UNITED STATES PATENT AND TRADEMARK OFFICE

| APPLICATION NO. | FILING DATE | FIRST NAMED INVENTOR | ATTORNEY DOCKET NO. | CONFIRMATION NO. |
|---|-------------|----------------------|---------------------|------------------|
| 10/791,269 | 03/03/2004 | Hyun-Jei Chung | 1568.1086 | 8941 |

Office Action Summary

DETAILED ACTION

D

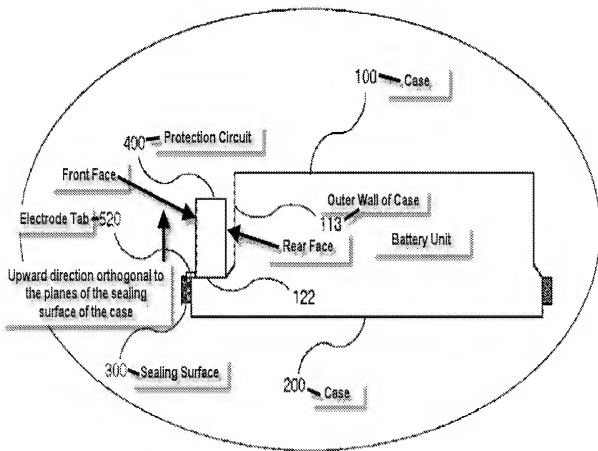
As seen in the cross-section D of figure 4 Jeong teaches a pouch-type lithium secondary battery comprising: a battery unit comprising: a positive electrode plate, a separator, and a negative electrode plate, wherein the separator is disposed between the positive and negative electrode plates; electrode tabs 510 and 520 extending from the positive and negative electrode plates of the battery unit; a case 100 and 200 having a space to accommodate the battery unit and a sealing surface 300 formed along the periphery of the space, a protection circuit board 400 having a front surface and an opposing rear surface and comprising electrode terminals disposed on the front surface, which are directly connected to the electrode tabs which extend through the case and are bent only once at a substantially right angle with respect to the planes of the sealing

surfaces at a predetermined length in a thickness direction of the case without extending beyond a thickness of the case, wherein the protection circuit board is disposed between an outer wall of the case and the bent electrode tabs, wherein the electrode tabs are disposed parallel to the outer wall of the case in an upright position and are perpendicular to a contact surface at which the sealing surface is contacted and the electrode tabs connect to the protection circuit board on a side opposite to the outer wall of the case (pages 4 and 5 of the provided English machine translation and as illustrated below).
